Epic Environmental Pty Ltd

19 March 2024 Ref: BAA220014.01

Subject: Responses to Mahalo North Pty Ltd A-EA-NEW-100521948 information request

Ozimops lumsdenae recorded & April 2022 at 1:17:32 am – moderate confidence call (shown in F6)

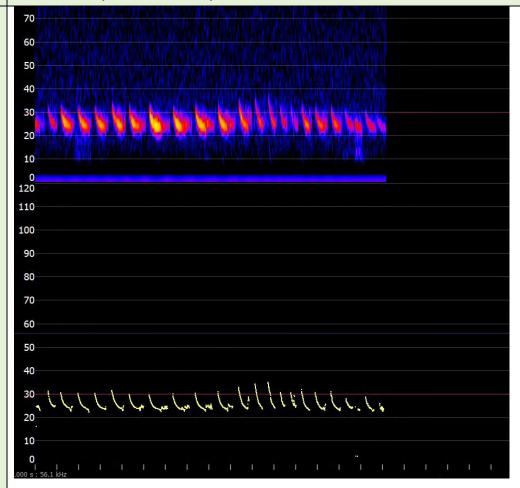
The survey identified the presence of the northern free-tailed bat *Ozimops lumsdenae* but has not provided information on how the identification of this species from the endangered large-eared pied bat *Chalinolobus dwyeri* was made. Without a good reference call data bank, these species can be difficult to differentiate.

Information is required on the source of ultrasonic reference material and methodology used to distinguish bat vocalisation recordings and match to the identified species. Further information should detail how the echolocation calls of *Ozimops lumsdenae* were distinguished from those of *Chalinolobus dwyeri*.

The calls were interpreted by Brett Taylor of Epic Environmental who has 15 years of ecological consulting survey experience. This includes attending a bat interpretation course run by Chris Corben (creator of the Anabat system) and 13 years of recording and cataloguing microbat calls across most of Queensland (excepting the far south-west and northern Cape York Peninsula). These calls are used by Brett as a reference library when interpreting calls from new surveys. Brett is a member of the Australian Bat Society and converses with Greg Ford (Balance Environmental) when a microbat call requires a second opinion. It is accepted that a bat call identification report was not appended to the Ecological Assessment Report. A reference call example of *Ozimops lumsdenae* collected during the survey is presented below. This is a 'moderate confidence call' as *Saccolaimus flaviventris* was also commonly present and the species calls can look similar – this call is considered to be of a call frequency above the general call range of *S. flaviventris* and there is no second or third harmonic on the full spectrum call (as is commonly the case with calls of *S. flaviventris*).

Indeed the two species call in a similar frequency range. But *Chalinolobus dwyeri* produces calls which alternate **quite distinctly** in frequency between each call. Pennay et al (2004) observe: "Can easily be distinguished from other species by the combination of the low frequencies and **distinct pattern of alternation** present in search phase calls". In other words the calls between the two species can be clearly differentiated. No calls of this kind were recorded.

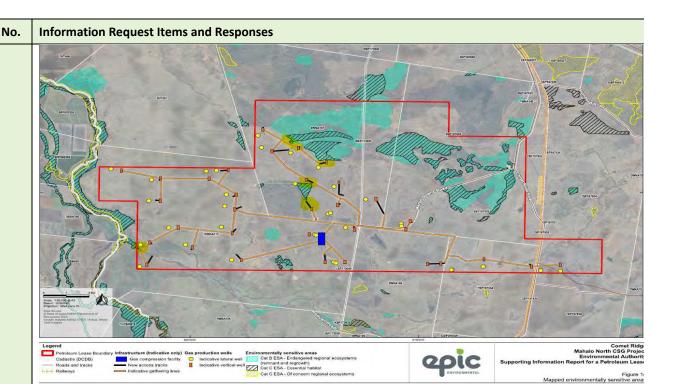
Marine plant (not in an urban area) – insert reference					
	None is identified within the project infrastructure footprint No					
	LEGALLY SECURED OFFSET AREA					
	Legally secured offset area – insert reference					
	None is identified within the project infrastructure footprint No					
10	Information Requested by DESI					
	<u>Issue</u> The application material states that the project will not disturb Environmentally Sensitive Areas (ESAs) protection zones. However, Figure 14 'mapped environmentally sensitive areas' of the 'Supporting Information Report' depicts some indicative vertical wells and access tracks adjacent mapped Category ESA areas (as highlighted in yellow below).

- 1. Please confirm the buffer distances between the mapped Cat B ESA on Figure 14 and the adjacent proposed disturbance.
- 2. Should the proposed disturbance impact the primary or secondary protection zone, please quantify the extent to which disturbance impacts within ESAs and their associated protection zones using the below table. These impacts should be listed against each protection zone trigger (i.e. Category B, Category C, and for each listing of 'Essential Habitat' or 'Of Concern', etc.). If certainty cannot be provided, justification should be provided that outlines appropriate risk management strategies to avoid impacts.

It is noted the ESA mapping as depicted in the Information Request (Figure 4 of the EAR) is based on the Department of Resources (DoR) mapping and not the ground-truthed mapping layer. Much of the Category B ESA mapping (Endangered Regional Ecosystems (REs)) is the result of vegetation polygons representing mixed REs. It is noted that 'applicants are encouraged to undertake ground-truthing surveys to accurately assess the RE type' in the DES EP Act information sheet: How to address environmentally sensitive areas and offset requirements in an application for an environmental authority for resource activities (DES 2020).

Ground-truthing of REs demonstrated that much of the vegetation is represented by RE 11.5.3 (No concern at present under the EP Act) and therefore is not considered to be a Category B ESA. Several polygons of vegetation communities considered Endangered under the EP Act were mapped as present following ground-truthing (RE 11.4.9, 11.5.16 and 11.3.1).

Category C ESA mapping applicable to Figure 4 of the EAR is for essential habitat mapped for Ornamental Snake. The species is very much associated with Brigalow communities on cracking clay soils and particularly where gilgais occur. These communities usually occur on land zone 4 (such as RE 11.4.9) but may also occur on land zone 3 (RE 11.3.1) and sometimes land zone 5 (RE 11.5.16). It is not associated with eucalypt

woodland (Poplar Box) communities on land zone 5, such as 11.5.3 which dominates the study area. An analysis of the extent of the project footprint within the ESA protection zones (primary protection zone (PPZ) and secondary protection zones (SPZ)) is provided in table below.
